Norfolk Vanguard Offshore Wind Farm

DCO Non- Material Change 2

Response to Points of Clarification Letter

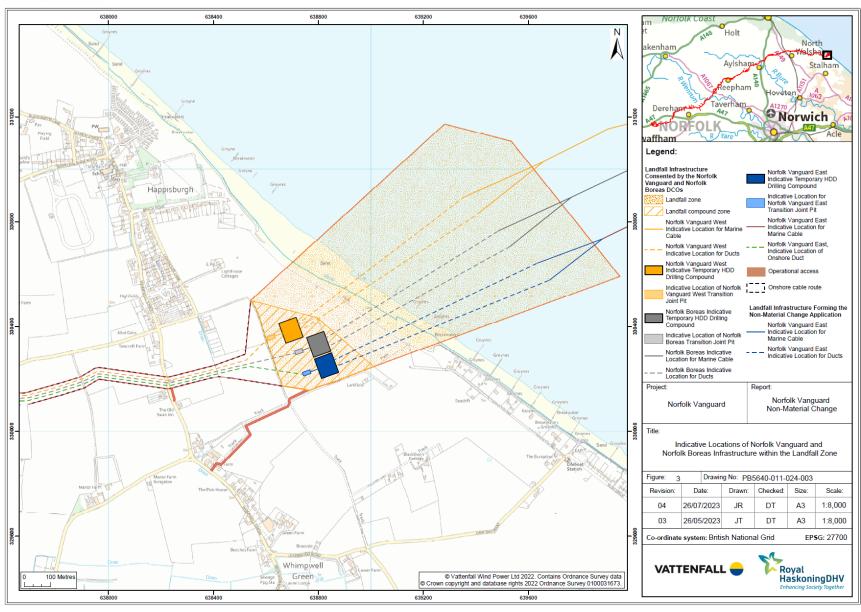
The Secretary of State notes that Figure 2 of the 2023 Application (Supporting Statement) appears to show physical cross-over between the landfall compounds of Vanguard with those of Boreas, which are shown in Figure 4.7 of the Boreas ES². The Applicant should provide a plan showing the layout at landfall which combines all details for both Vanguard and Boreas.

- 14. The Applicants' response is as follows:
- 15. It is important to note that Figure 4.7 of the Norfolk Boreas ES shows "indicative" landfall compound locations and that the DCOs allow for these to be located anywhere within the Landfall compound zone. The same applies to Figure 2 of the NMC2 application. Some further detailed design work has occurred in order to progress the NMC2 application; however, the exact locations of the landfall compounds will only be confirmed at the point at which the Landfall Method Statements (secured through Requirement 17 of the Norfolk Vanguard and Norfolk Boreas DCOs) are approved.

- 16. The Applicant has provided a plan below showing an indicative layout at landfall which combines landfall infrastructure under the Norfolk Vanguard and Norfolk Boreas DCOs. This was not included within the NMC2 Supporting Statement as the application is only to change the Norfolk Vanguard DCO and it was considered that it may cause confusion to include Norfolk Boreas infrastructure given that there is no equivalent NMC application to change the Norfolk Boreas DCO.
